139 FERC ¶ 61,247  
UNITED STATES OF AMERICA  
FEDERAL ENERGY REGULATORY COMMISSION

Docket Nos. RM12-6-000 and RM12-7-000

Revisions to Electric Reliability Organization Definition of Bulk Electric System and  
Rules of Procedure

ACTION: Notice of Proposed Rulemaking.

**Figure 1**

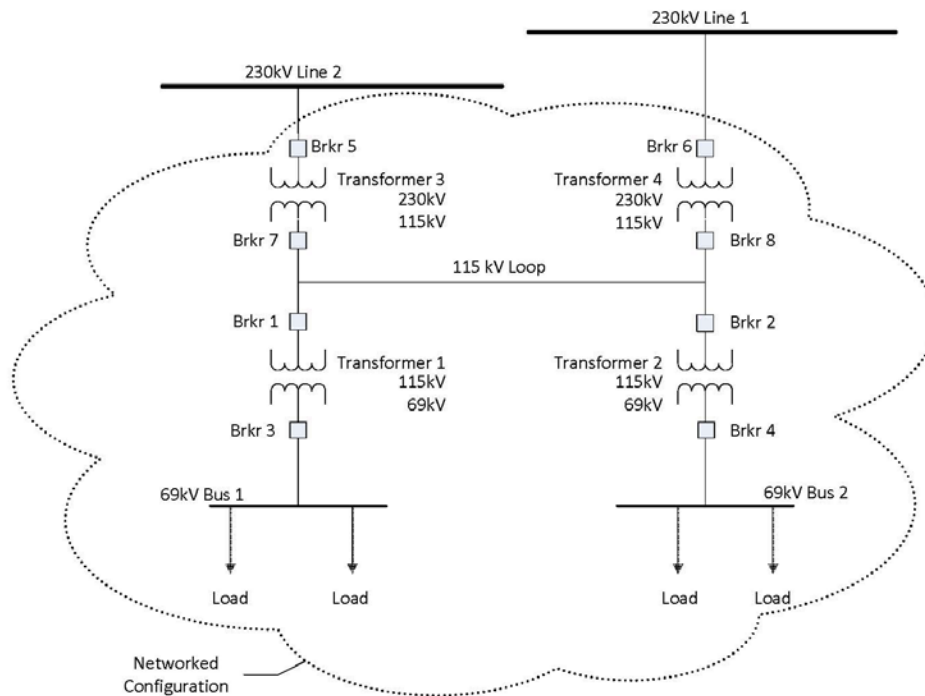
79. Figure 1 below depicts facilities configurations in which all of the 230 kV and 69 kV transmission elements emanate from a single point of connection of 100 kV or higher. The Commission seeks comment on whether each of the radial systems shown in figure 1, the 230 kV elements above each transformer to the point of connection to each 230 kV line, respectively, are excluded from the bulk electric system pursuant to exclusion E1.

**Figure 2****Networked Configuration w/115 kV Loop**

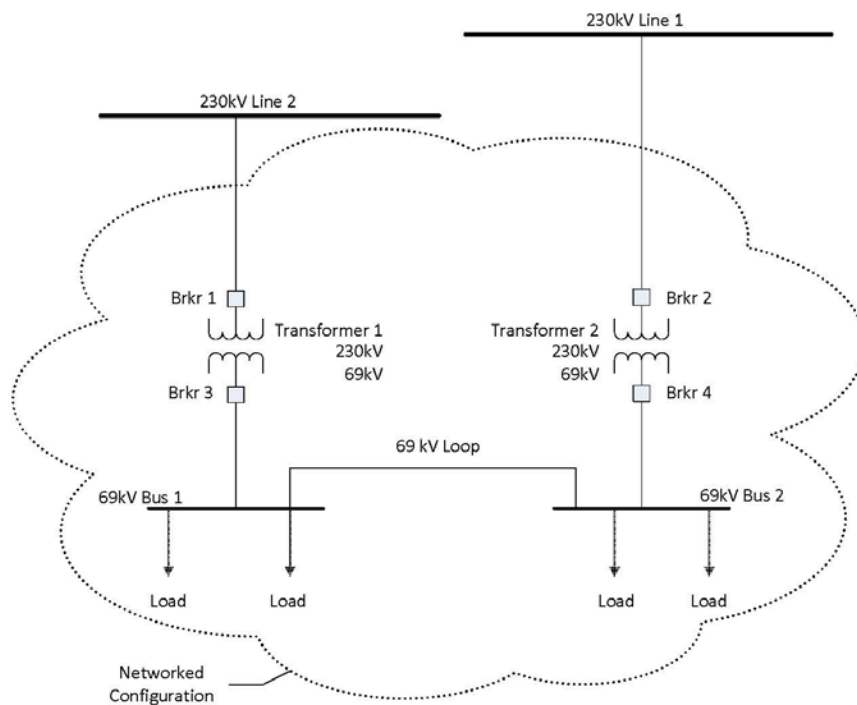
80. Another scenario shown in figure 2 below depicts a configuration containing a 115 kV loop, with the configuration emanating from two points of connection of 100 kV or higher. We seek comment whether, in this configuration, the 115 kV and 230 kV elements above Transformers 1 and 2 to the points of connection to the two 230 kV lines would be excluded from the bulk electric system pursuant to exclusion E1. Is the configuration shown in figure 2 more appropriately analyzed pursuant to the “local network” exclusion E3 and, if so, what if any elements operated at or above 100 kV would be excluded pursuant to exclusion E3?

**Figure 4**  
**69 kV Networked Configuration with Normally Open Switch**

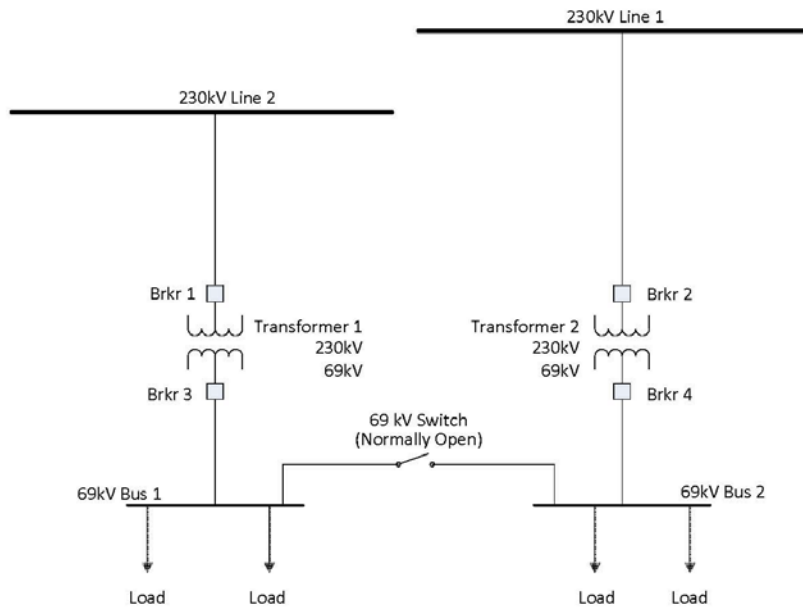
86. Figure 4 below illustrates a configuration with a normally open switch.

switch' in such configuration is well understood in the electric utility industry.”<sup>105</sup> We seek comment on NERC’s characterization and whether the phrase “normally open” is subject to interpretation or misunderstanding, or whether a “normally open” configuration is potentially difficult to oversee. Further, we seek comment on the need of transmission operators or other functional entities to study the system impacts of the closing of a “normally open” switch, or to take other steps to ensure awareness of the impacts of the loop that is created by the closing of the switch if the closed loop is not included as part of the bulk electric system.

**Figure 5****Networked Configuration w/69 kV Loop**

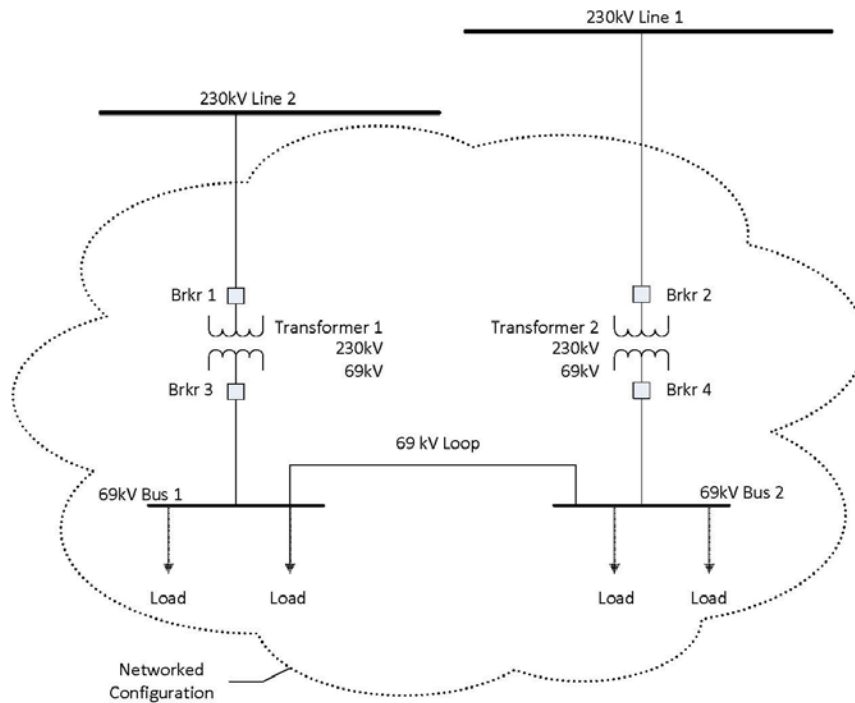
95. As stated above, exclusion E3 defines local networks as “[a] group of *contiguous* transmission Elements *operated at or above 100 kV but less than 300 kV* that distribute power to Load rather than transfer bulk-power across the interconnected system.” While the local network exclusion applies to contiguous transmission elements operating at a minimum of 100 kV, it is unclear how the exclusion applies to a looped lower voltage system. For example, figure 5 depicts a 69 kV looped system emanating from two points of connection at 100 kV or higher.

The configuration in figure 5 depicts a group of elements that are contiguous through a 69 kV loop. We seek comment whether the configuration in figure 5 qualifies as a local network and, in particular, whether the configuration satisfies the condition that a local network consists of “a group of *contiguous* transmission Elements *operated at or above 100 kV....*”
